**REVIEW TYPE:** Preliminary Plan Review

**APPLYING FOR:** Resubdivision of Pt. of Lot 16, Pt. of Lot 18 and Lot 17

**PROJECT NAME:** Garrett Park Section 1

**CASE #:** 1-04102

# NEIGHBORHOOD DELINEATION

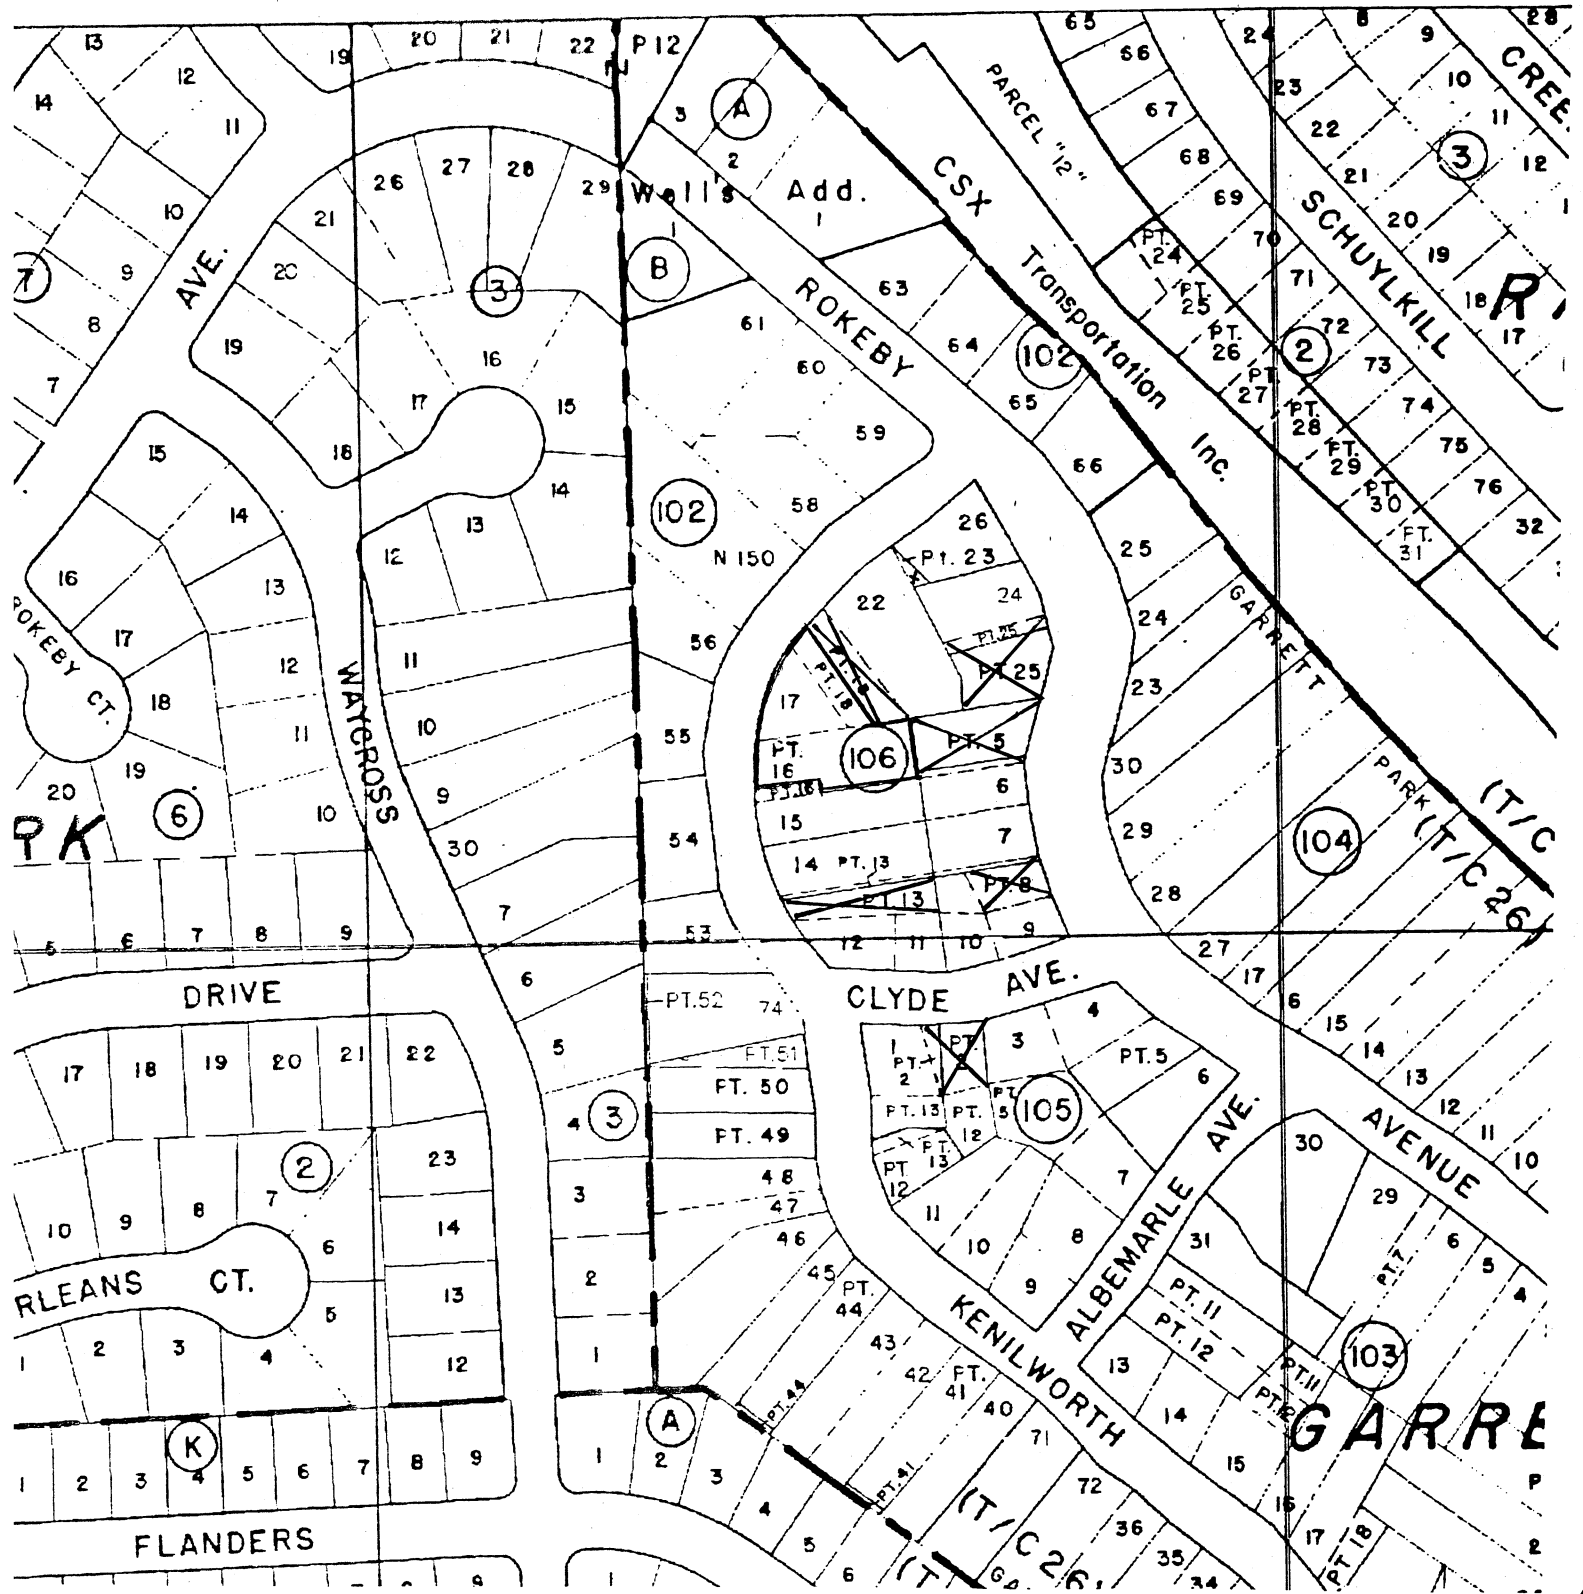
The defined neighborhood used in the evaluation of this resubdivision contains 22 lots as shown on the attached neighborhood delineation. Lots in the neighborhood vary widely with respect to size, shape, width, frontage and area. Many parts of lots exist in close proximity to the subject property that were not, as is Planning Board practice, included in the defined neighborhood because there is no assurance that they meet the minimum zoning standards.

Staff has provided the identical neighborhood delineation that the Planning Board considered as part of the pre-preliminary plan. The neighborhood provided provides an adequate sample that exemplifies the lot and development pattern of the area.

**PRE-APPLICATION CONCEPT PLAN**

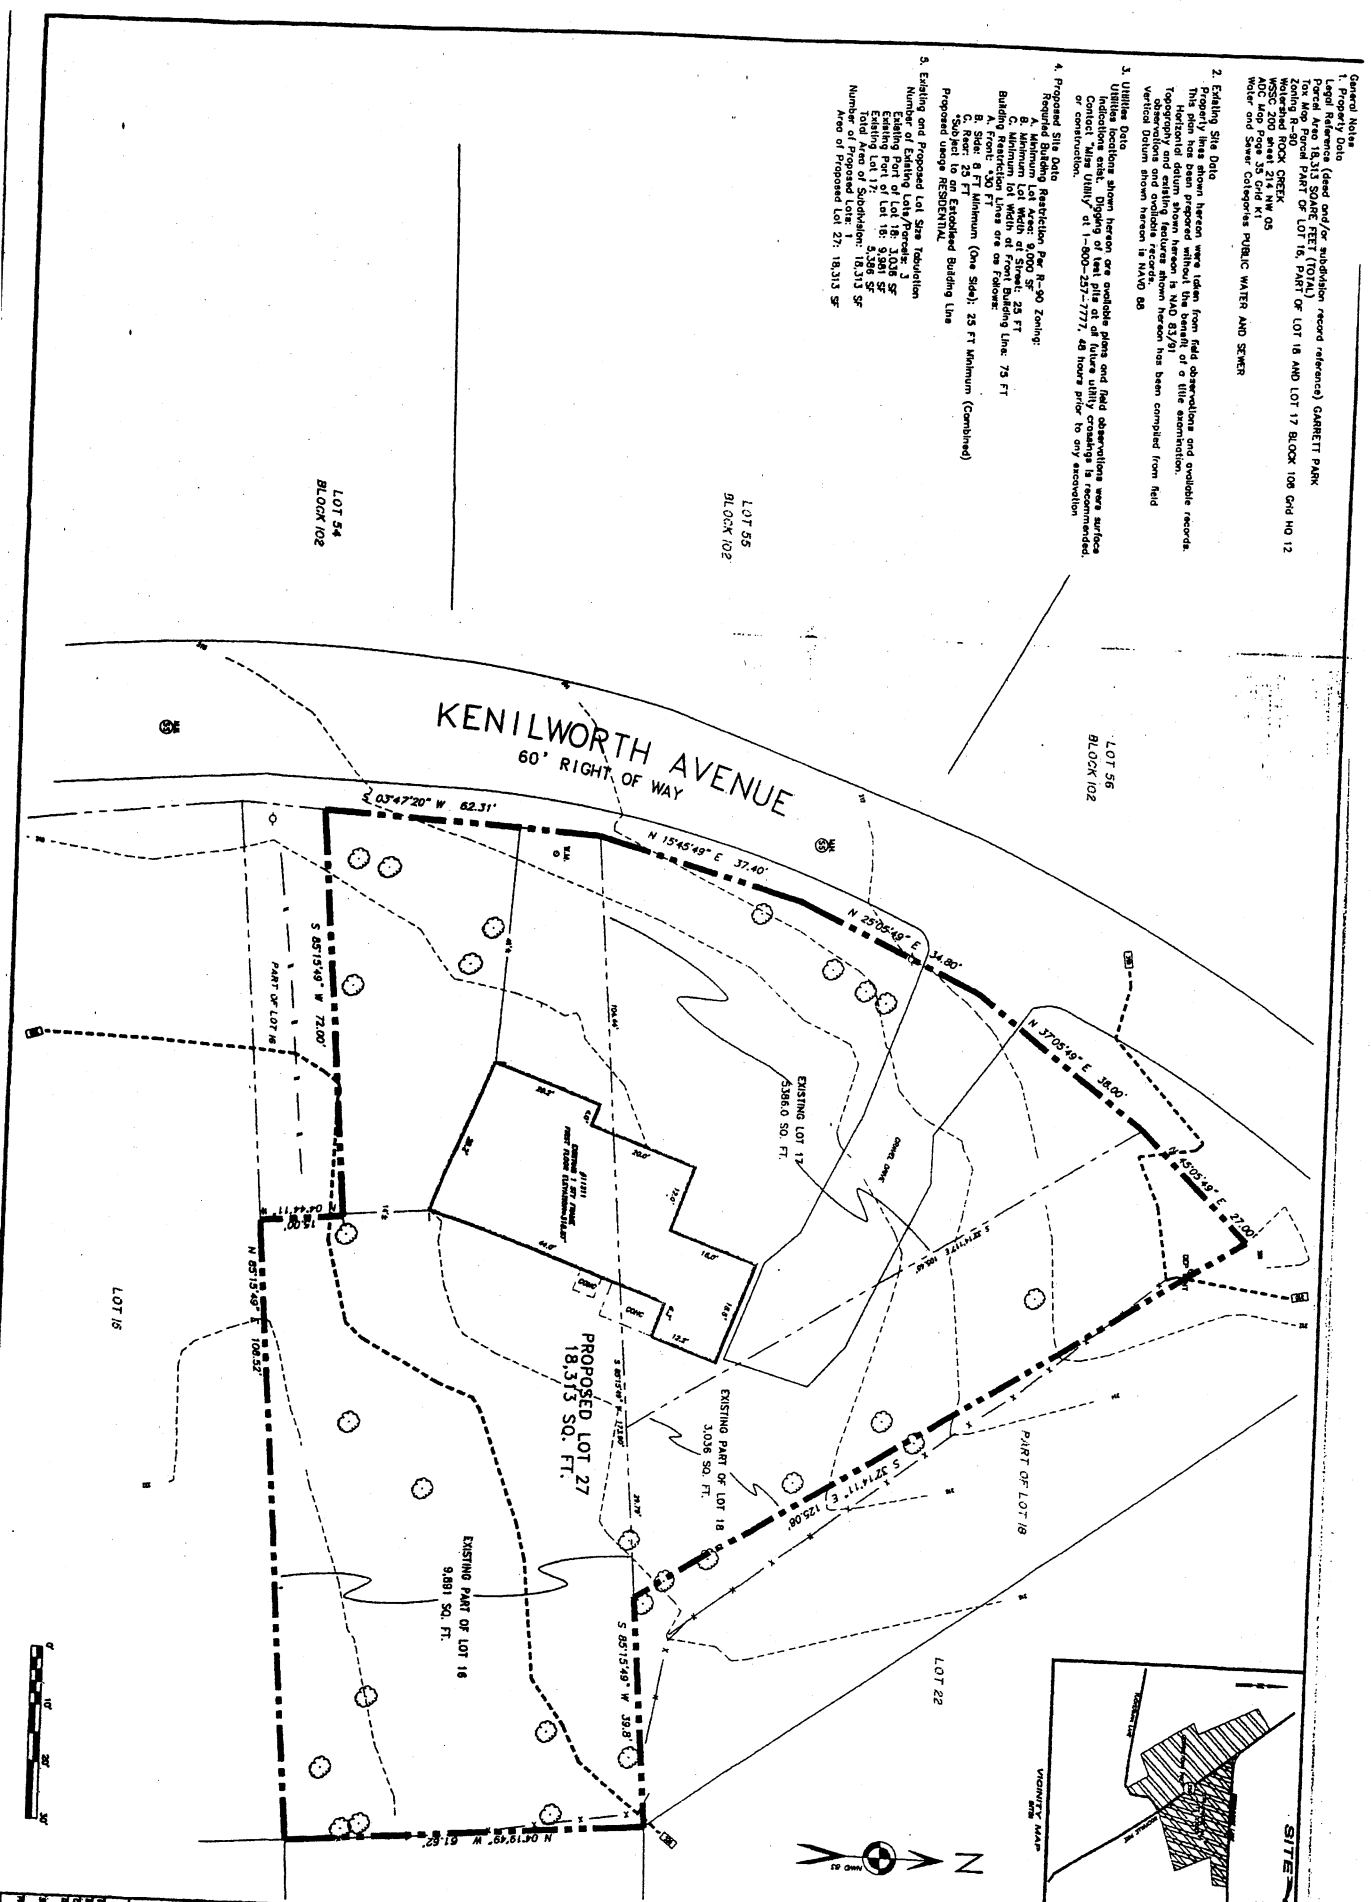
After a review of the plan, dated 1/7/2004, regarding the consolidation of Lot 17 with portions of lots 16 and 18, the Town finds no reason to object to the formation of proposed Lot 27.
